**YARRA CITY COUNCIL**  
**Internal Development Approvals Committee**  
**Agenda**

- 
- 1.1 PLN16/0829.01 - 363 George Street, Fitzroy - Amendment to Planning Permit PLN16/0829 to include the allotment known as Lot1 TP428690, and for alterations to the design, setbacks and massing of the approved built form including two additional levels of dwellings (eight storeys in total), modifications to the mix and internal layout of the shop and dwellings (permit required use) and a reduction in the car parking requirements**
-

1. This report provides Council with an assessment of an application to amend planning permit PLN16/0829 and recommends approval subject to conditions.

Figure 3: Extract from Site Detail Plan showing Lot 1 TP428690 highlighted.

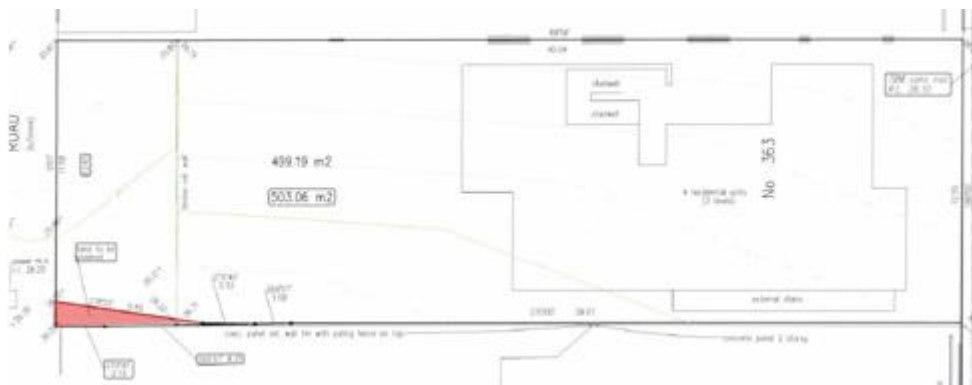
15. The amendment proposes the inclusion of the allotment known as Lot 1 TP428690. This is a triangular shaped allotment that “squares off” the larger lot parcel at the south-western corner, as shown in Figure 3.

Figure 9: Endorsed rear elevation

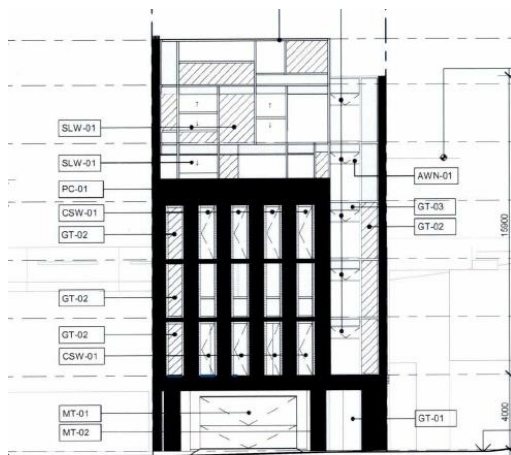
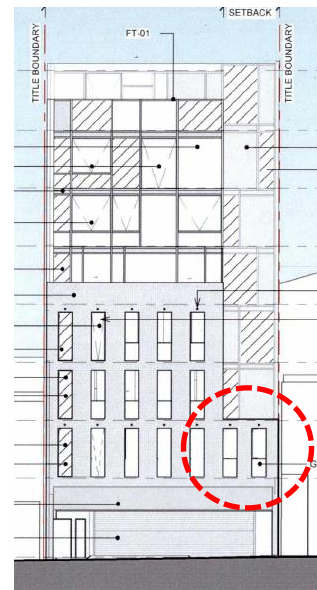
121. As identified within the comments received from the Urban Design Unit, the amended proposal seeks to increase the overall height from six to eight storeys with the six storey envelope generally aligning with the previously approved scheme. There is no appreciable change to the proposed street wall.
122. The amendment results in the inclusion of Lot 1 TP428690 to "square off" the larger allotment at the south-western corner. As a result, the southern portion of the rear wall is extended to the first storey, as the comparison in Figure 9 and 10 identifies.

123. The additional site area results in the ability for the proposal to accommodate more built form in this location. The two-storey on-boundary wall in this location provides a transition to the car parking area associated with the adjoining commercial building to the south, noting that built form of up to five storeys flush to the boundary is the prevailing character within this laneway. For these reasons this modification is considered acceptable.

Figure 11: Sight lines from the opposing side of George Street

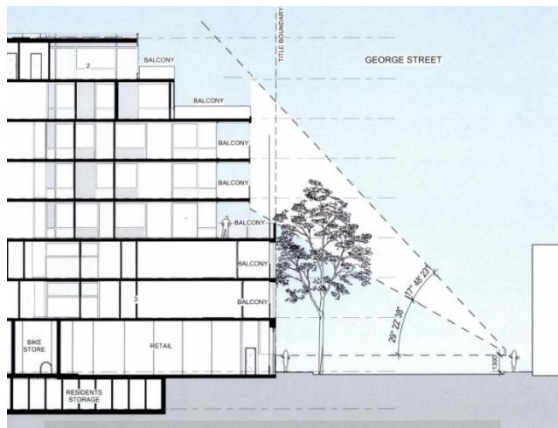
124. The sixth and seventh level will be setback from the street by 2 metres and 7.7 metres respectively to balcony forms and 7.699 metres and 10.763 metres to the built form. This is demonstrated in Figure 11.

126. Schedule 10 to the Design and Development Overlay recommends that development above the street façade height should be setback and not exceed four to six storeys. The development exceeds six storeys, at eight storeys, however it is considered that the robust surrounding context and proximity to Johnston Street provide sufficient justification for higher form. Upper levels are significantly setback and visual intrusion when viewed from the opposing footpath has been sufficiently managed with the uppermost levels built form restricted to a balcony at the sixth floor and the seventh floor concealed from view (as demonstrated in the previous sightline diagram).

Figure 12: Decision Plans, Level 1 (rear)

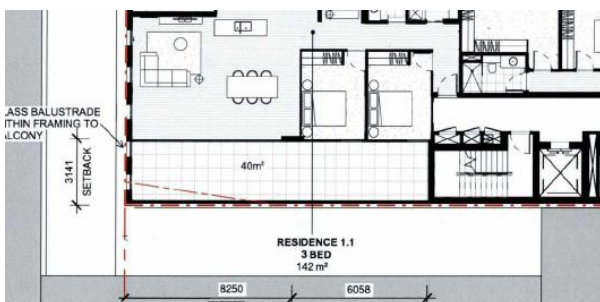
184. As identified in the previous report, Objective 2.6 of the GHDRD aims to ensure areas can develop with an equitable access to outlook and sunlight. The design suggestions call for the consideration of the possible future development of adjoining sites and allow, as best as possible, for an equitable spread of development potential throughout an area.
185. The amended design continues to provide equitable development opportunities for the surrounding allotments. The design continues to utilise the George Street and rear laneway frontages for all primary outlooks. The plans were formally substituted to address an identified issue at level 1 with the previous plans, where a limited setback was provided to the southern boundary. The floorplate has been modified, and unit 1.1 is now setback 3.14 metres from the southern boundary. This is shown in Figure 11 and Figure 12.

186. Whilst the balcony is located along the southern boundary, it does have an unobstructed outlook to the west and would not prejudice future development on the adjoining site.
187. The previous decision required single aspect living rooms where facing the rear to be setback a minimum 4.5 metres from the centre of the laneway. There is only one apartment that provides a single aspect living room that faces the laneway. The living room of residence 2.1 is setback 4.389 metres from the centre of the laneway. A condition will be included to ensure that the living room to this apartment is compliant with this setback, to ensure equitable development of the property on the western side of the right of way is not impacted.
